PEACH BOTTOM ATOMIC POWER STATION, UNIT NO. 2

AMENDMENT TO FACILITY OPERATING LICENSE

Amendment No. 45
License No. DPR-44

SAFETY EVALUATION BY THE OFFICE OF NUCLEAR REACTOR REGULATION

Figure 3.6.4

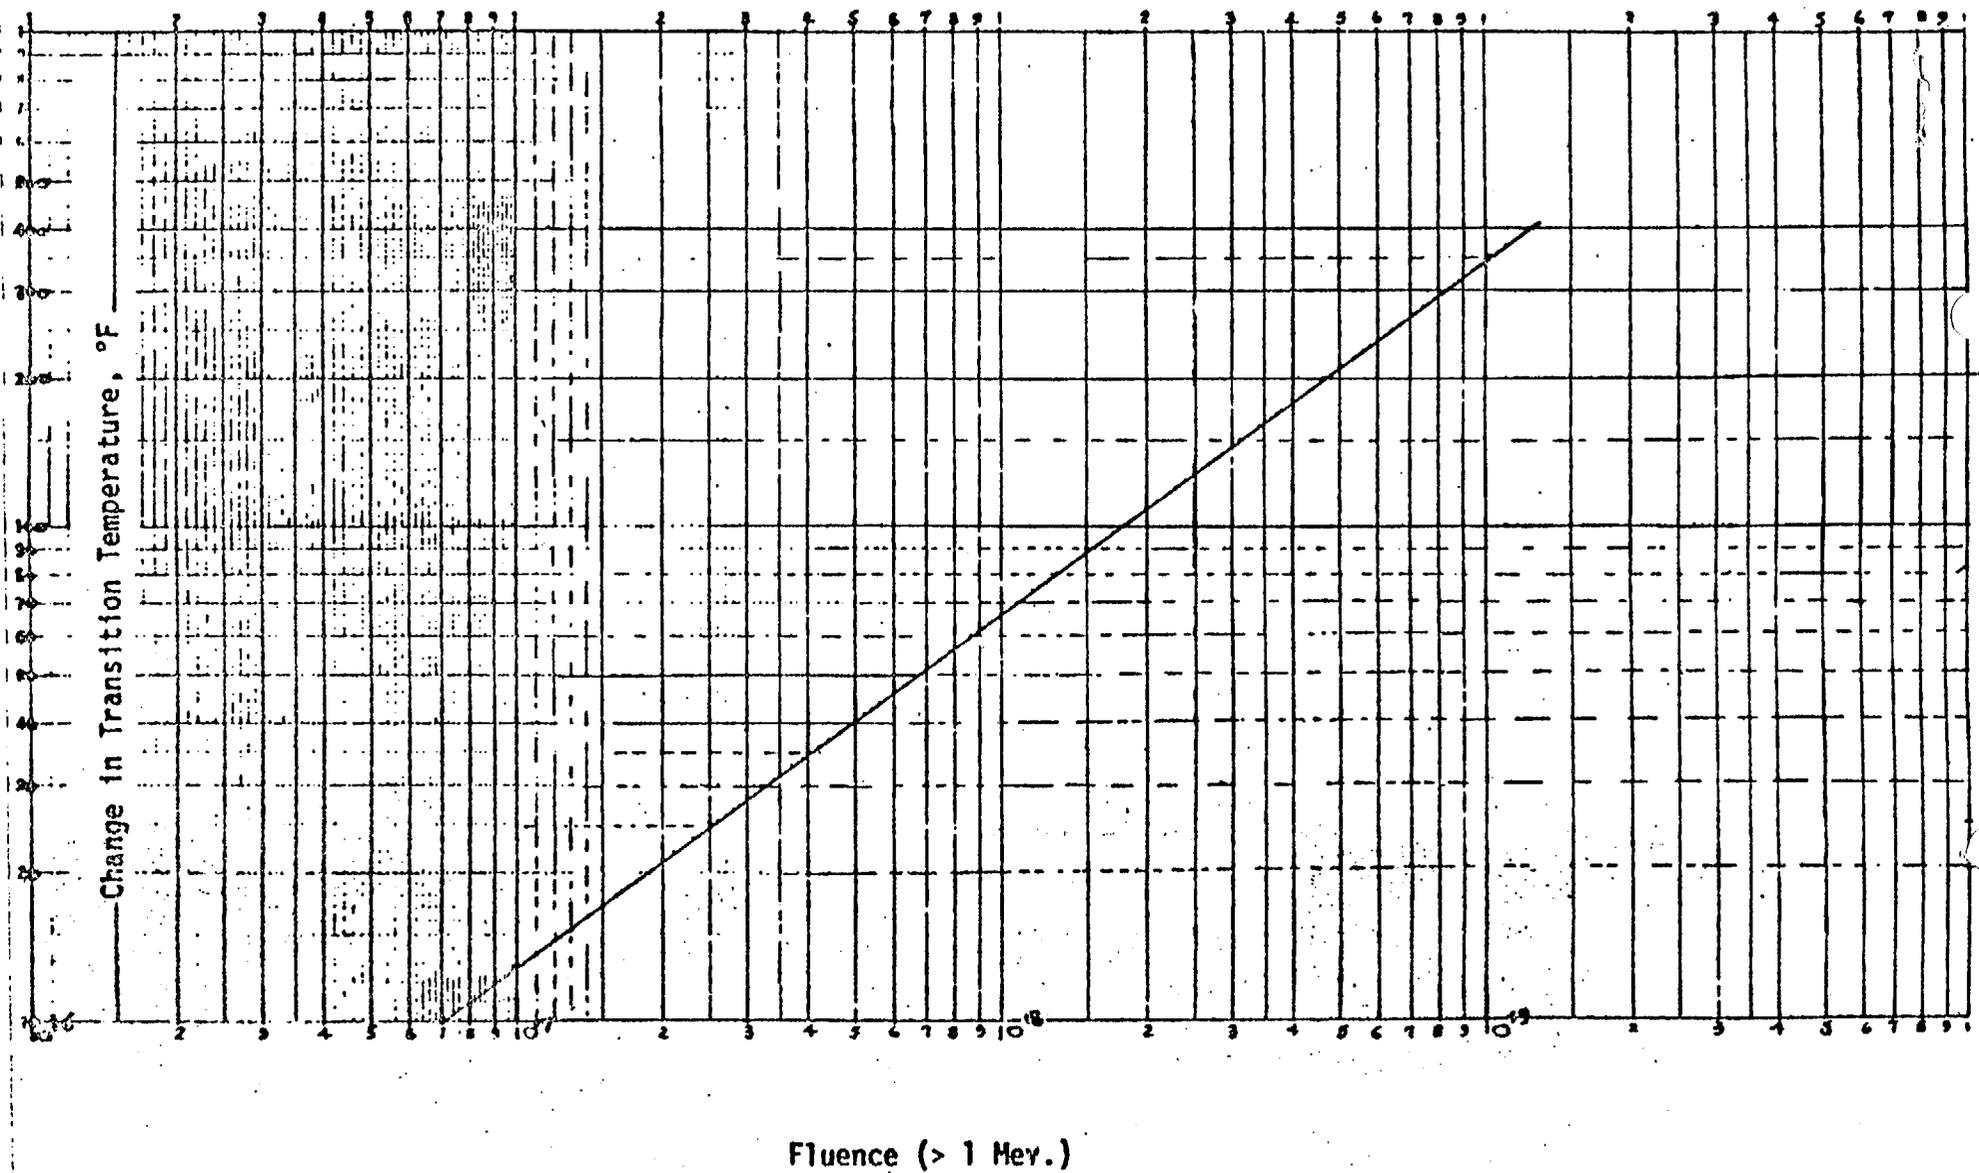
Selected neutron flux specimens shall be removed during the third refueling outage and tested to experimentally verify or adjust the calculated values of integrated neutron flux that are used to determine the RTNDT for Figure 3.6.4.

Neutron flux wires and samples of vessel material are installed in the reactor vessel adjacent to the vessel wall at the core midplane level. The wires and samples will be removed and tested to experimentally verify the values used for Figure 3.6.4.
